Eastleigh Railway Depot Campbell Road Eastleigh

Ground Floor Plan

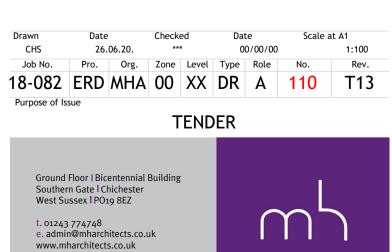
T08	doors at either end omitted to save costs Unit 210 Mezzanine amended for fitout Unit 210 WC changed External wall types updated		- 18.01.2	0 CS	18.01.20
тла	External wall types updated	IFI	16 02 2	1 09	16 02 21

T09 Columns updated to SE Specification JEL 16.02.21 CS 16.02.21 Surround amended to enclosed Columns T10 Amendments YM 27.04.21 CHS 19.04.21

-Key updated -Insulation added to walls surrounding the core

-Roof/lid to unit 205 FF added

- -Doors and partition to disabled toilet moved into entrance -Platform lift added to core of stairs to units 200 & 210
- T11 Construction key amended to clarify party walls and add 2nd layer of plasterboard to first floor partitions. CHS 01.06.21
- T12 Mezzanine reinstated. CHS 05.07.21.
- T13 Loading bay door to East elevation JK 15.11.21 CHS 15.11.21 and mens toilet omitted
